Model: Lef-C1	Date: 29-Jan-16	No.: RD259006
---------------	-----------------	---------------

Subject: Firmware Release Note: RPCS		Prepared by: Y. Saitoh	
From: 1st Tech Service Sect., MFP/Printer Tech Service Dept.			
Classification:	<input type="checkbox"/> Troubleshooting <input type="checkbox"/> Mechanical <input type="checkbox"/> Paper path <input type="checkbox"/> Product Safety	<input type="checkbox"/> Part information <input type="checkbox"/> Electrical <input type="checkbox"/> Transmit/receive <input checked="" type="checkbox"/> Other (Firmware)	<input type="checkbox"/> Action required <input type="checkbox"/> Service manual revision <input type="checkbox"/> Retrofit information <input checked="" type="checkbox"/> Tier 2

This RTB has been issued to announce the firmware release information for the **RPCS**.

4. Replacement and Adjustment > Adjustment after Replacement
 > ARDF Image Adjustment > Skew Adjustment (p309~)

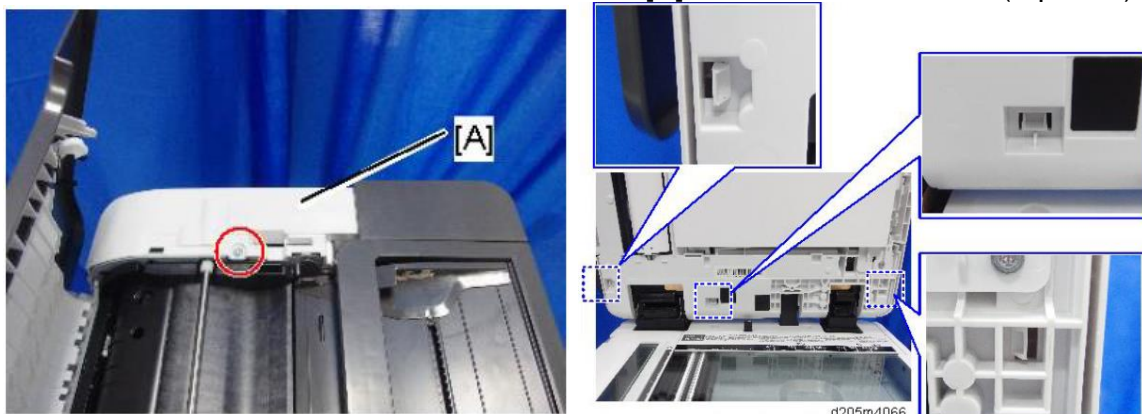
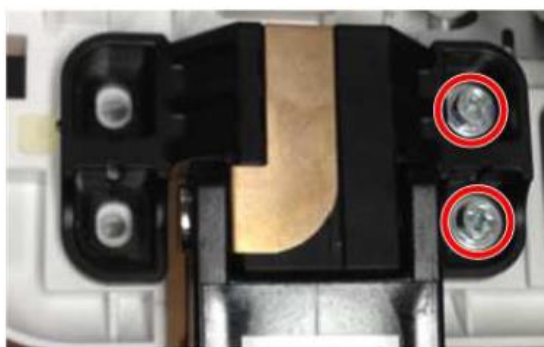
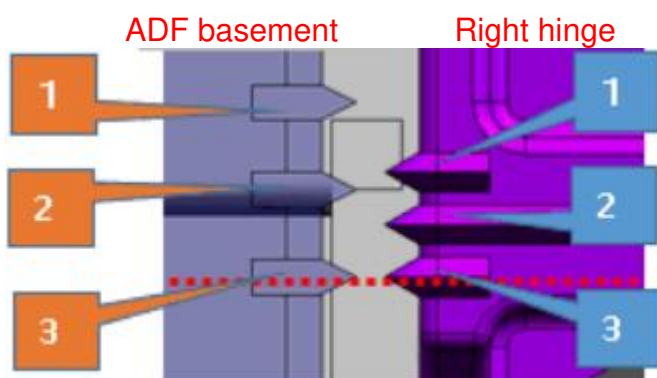
Several steps were missing from the procedure for adjusting the ADF skew.
Please add the steps in red below.

1. Remove the ARDF rear cover.

Remove one screw from the ARDF rear cover [A], and release the tabs (3 points).

2. Remove the ARDF. (page 158)

3. Remove the right hinge (screw x4).

4. Remove the two parallel pins.

5. Attach the hinge using four screws temporarily with the appropriately spaced along the adjustment slots. Fasten the screws on the right side first.

6. Move the hinge for adjustment, and then fasten the screws. Adjustable range is:
ADF basement [1] and Right hinge [1] to ADF basement [3] and Right hinge [3]

Fig.10

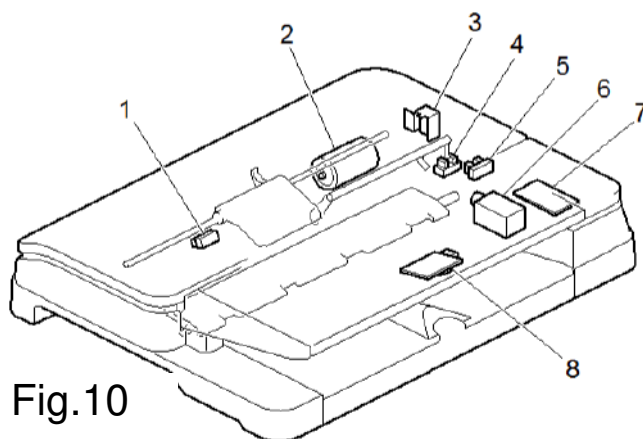
The following contents were added.

MP 305+ SP/SPF Component Layout

Important Notice about Machine Installation or PCDU replacement.

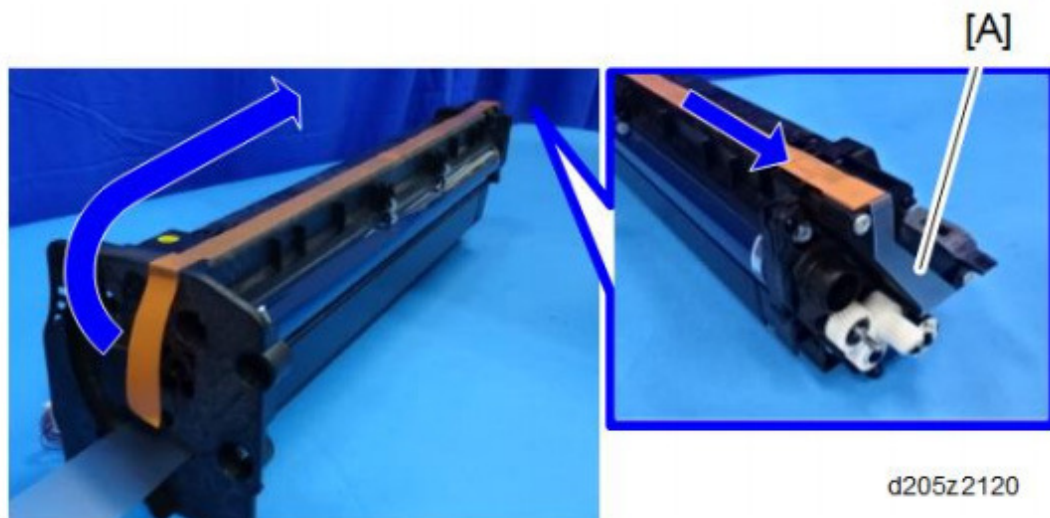
- When you install the machine ***or replace PCDU***, make sure to remove the protective sheet [A] and heat seal [B] from the development unit.
- If you do not ***do this remove protective sheet [A], toner cannot be supplied to development unit and*** toner will coagulate and clog inside the toner pipe ***in Mainframe.***
- If you do not ***do this remove heat seal [B], no image appears.***

For the procedure, see the Field Service Manual.

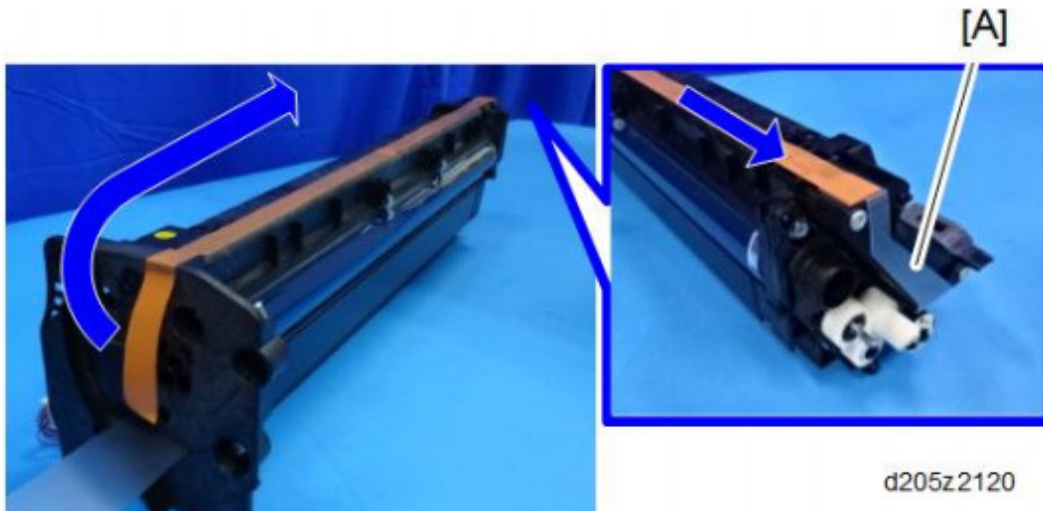
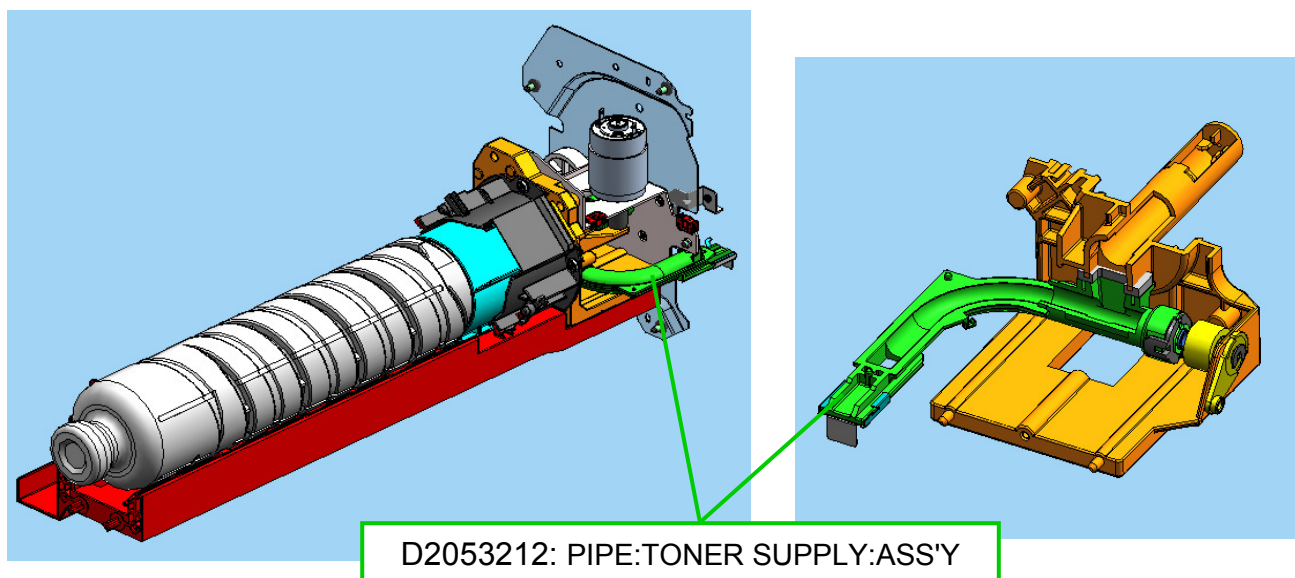
Toner Bottle replacement message does not disappear even the Toner Bottle is not empty.

The protective sheet [A] is not removed at machine installation or PCDU replacement. As a result, toner coagulates and clogs inside the toner supply pipe (machine-side).

- **Make sure to remove the protective sheet** at machine installation and whenever you replace the PCDU.
- If the symptom has already occurred, replace the toner supply pipe (P/N: D2053212).

P/N	Description	Q'ty
D2053212	PIPE:TONER SUPPLY:ASS'Y	1

4. Replacement and Adjustment > Operation Panel (P184)

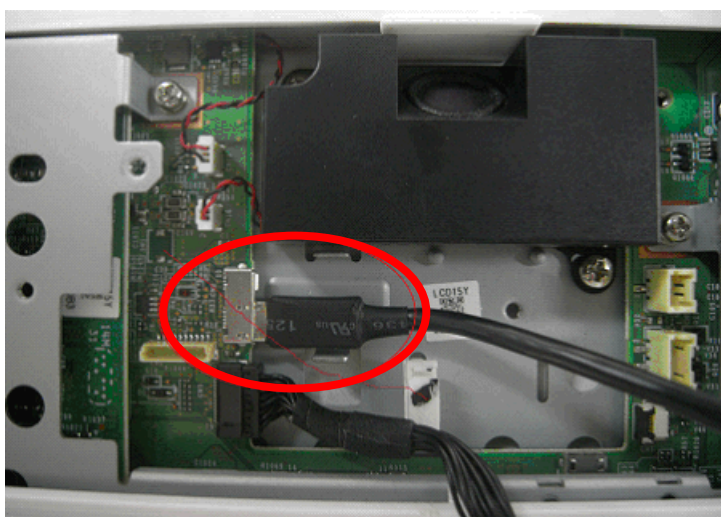
Please add the following description after the operation panel replacement procedure.

When reconnecting the USB cable, make sure it is connected in the right location. If it is not connected correctly, SC672-11 is displayed.

U013
MAIN DRIVE

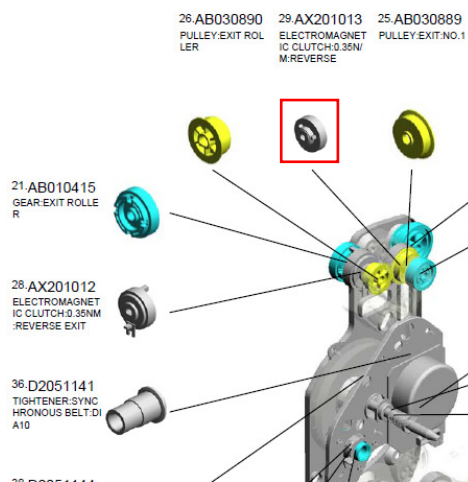
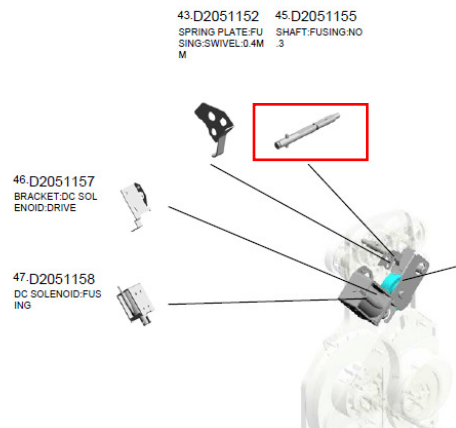
Paper jams (Jam code 065) frequently occur when making duplex prints. The shaft (D2051155) of the electromagnetic clutch (AX201013) is wet with oil and the problem is resolved after replacing the clutch.

Oil comes out from the bushing of the shaft when the temperature of the bushing increases by the fusing heat. The oil travels on the shaft and goes into the clutch causing the problem.

Replace the clutch (AX201013) and clean the shaft with dry cloth to remove remaining oil.

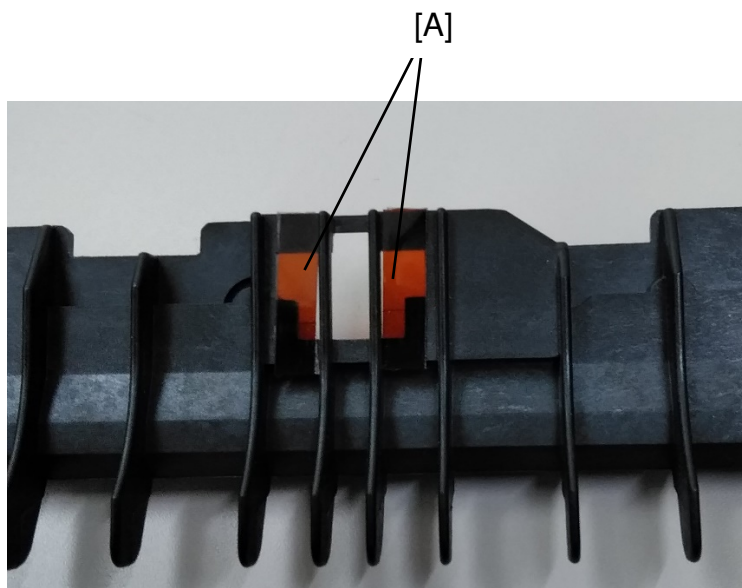
Paper exit jams (Jam code 020) occur frequently, especially when the inside of the printer is cold (such as in the morning).

The heat from the fusing process causes the oil-based components in the toner to evaporate and gradually accumulate on the shaft of the exit sensor feeler. If the inside of the printer is cold, the oil solidifies and interferes with the movement of the feeler.

Two plastic seals [A] (D2054409) were added to cover the opening of the fusing unit guide (which will block the airflow toward the sensor).

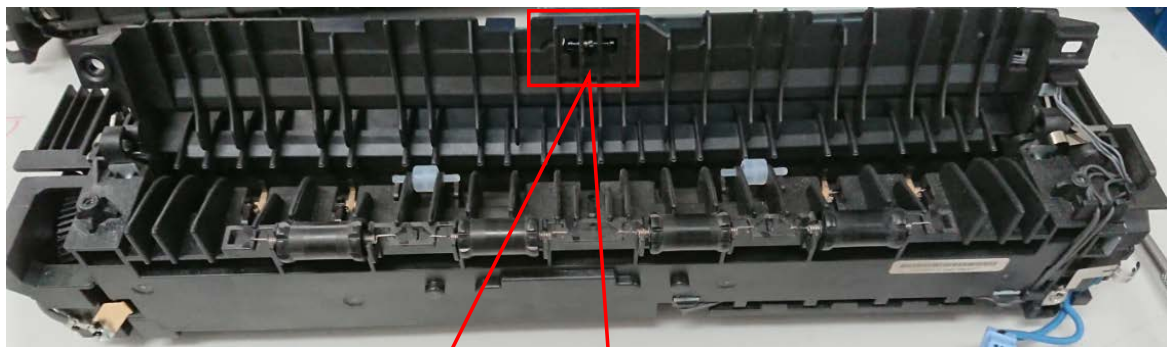
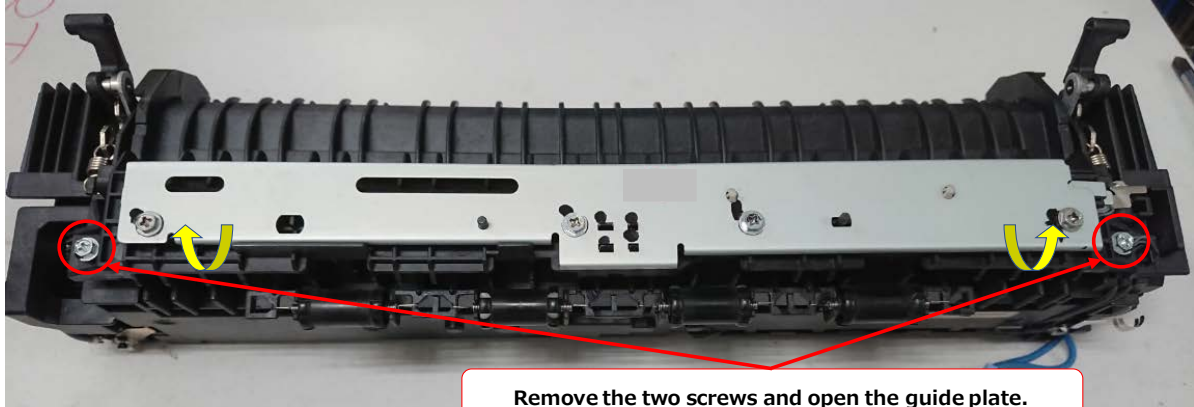
In the field:

Attach the Mylars as shown below.

Paste the two Mylar sheets as shown below.
